Request for Additional Information No. 90 (1077), Revision 0

U. S. EPR Standard Design Certification

Docket No. 52-020

SRP Section: 06.02.02 - Containment Heat Removal Systems

Figure 06.02.02-7-1—TSP Basket Location with Respect to the ECCS Sump Blockage Design Mitigation Features

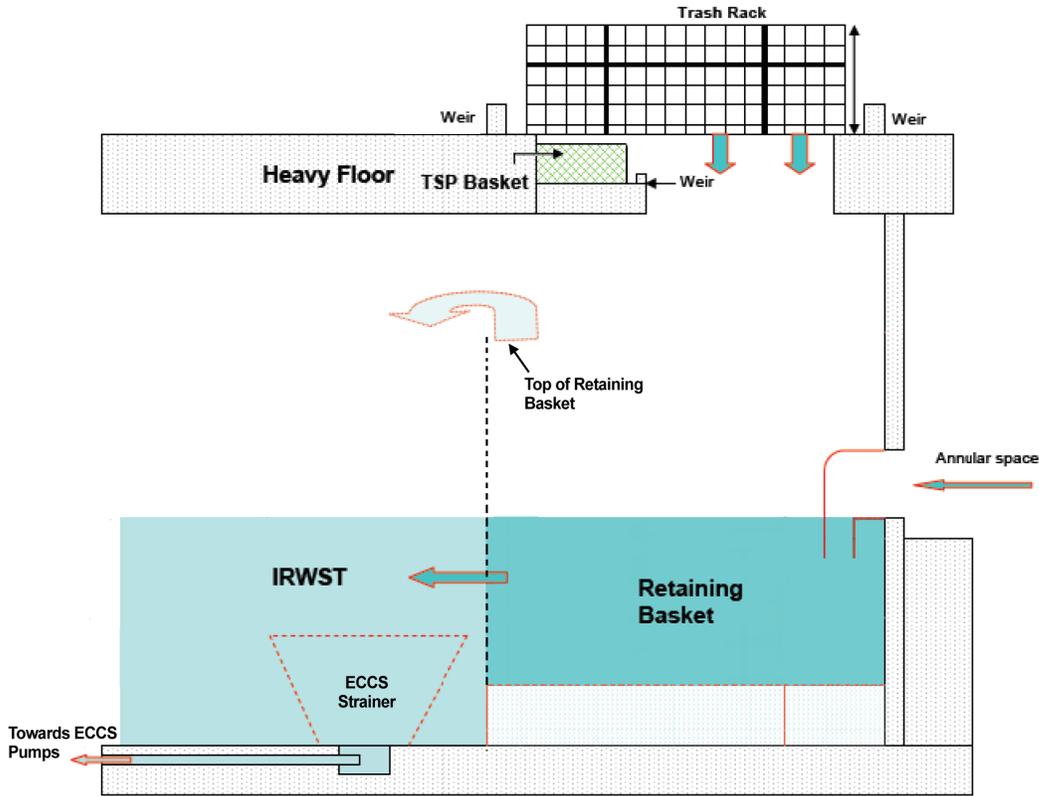
The EPR FSAR provides only a very limited description of the TSP-C material packaging and its location. The description, in Tier 2 section 6.3.2.2 pages 6.3-9 - 6.3-10 reads as follows: "Coolant pH adjustment baskets containing granulated trisodium phosphate dodecahydrate (TSP-C) are strategically placed in the inlet flow path to the IRWST within the boundary perimeter of the weirs at the four heavy floor openings of the RB." (Reactor Building) "Flow through the baskets dissolves the TSP-C into the coolant that returns to the IRWST to passively neutralize entrained acids and maintain the alkalinity of the coolant." Drawings and figures in the FSAR and ANP-10293 do not show any components in the locations mentioned above except the retaining baskets. However, the location described above does allow drainage from the containment annular flow path to bypass the TSP material and flow into the IRWST thereby provide a diluting stream of primary coolant condensate following a LBLOCA event. Please provide:

1. Information (drawings, figures, schematics, etc.) that shows the specific locations of the TSP-C packaged material and their support structures. In addition, provide a description of the coolant condensate drainage flow paths and estimated quantities that are directed towards the TSP-C material and those that bypass the TSP-C material.
2. A description of the impacts on pH control of the IRWST considering the bypass flow that does not come in contact with the TSP-C packaged material before entering the IRWST and the potential blockage of expected condensate flow paths to the TSP-C packaged material.
3. The purity specifications that have been developed by AREVA for the TSP-C material particularly related to low concentration impurities such as lead (Pb) (since TSP-C is also a chelating agent) which is a common impurity of TSP-C.

The trisodium phosphate (TSP) baskets are located in the containment heavy floor opening below the in-containment refueling water storage tank (IRWST) trash racks. Figure 06.02.02-7-1 below shows the location of the TSP basket for each of the four heavy floor openings, and their relation to the emergency core cooling system (ECCS) sump blockage mitigation design features. Figure 06.02.02-7-2 shows the structure of the TSP basket.

The drainage flow path from the released coolant following a loss of coolant accident (LOCA) condenses on the walls of the loop compartment and flows down to the heavy floor at the bottom of the loop compartments. The LOCA water collects on the reactor building heavy floor and drains to the IRWST through four separate flow openings in the heavy floor. Each of the four openings contains an assembly consisting of a weir, trash rack, and TSP basket. Approximately 83% of the ECCS return flow will pass through the heavy floor openings, dissolving the TSP chemical in each of the four TSP baskets. The remaining 17% of ECCS return flow drains through the annular openings to the IRWST. The ECCS return flow (83%) that passes through each of the heavy floor openings and TSP baskets drains into the IRWST retaining baskets. The remainder of the ECCS return flow (17%) that drains through the annular openings also drains to the IRWST retaining baskets.
